**Re: Mine Inspection June 7, 2008**  
**Property: Mount Polley Mine**

**Report of Inspector of Mines**

**Geotechnical**

Inspection No.: 15354  
File: 18040-02-07  
Mine No.: 1101163  
Emp/Cont: 0 / 0  
Orders H&S: 2 RECL 0  
Stop Work: 0

Fig. 1

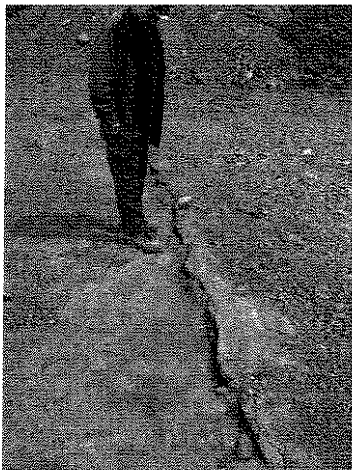
Tension crack was noticed developing on the south west crest of the pit (Fig. 1). It appeared the crack was aligned with the main

fault structure striking North-West direction. The movement of the tension crack shall be monitored with both prism monitoring and by inserting steel pins on both side of the crack and monitoring the displacements.
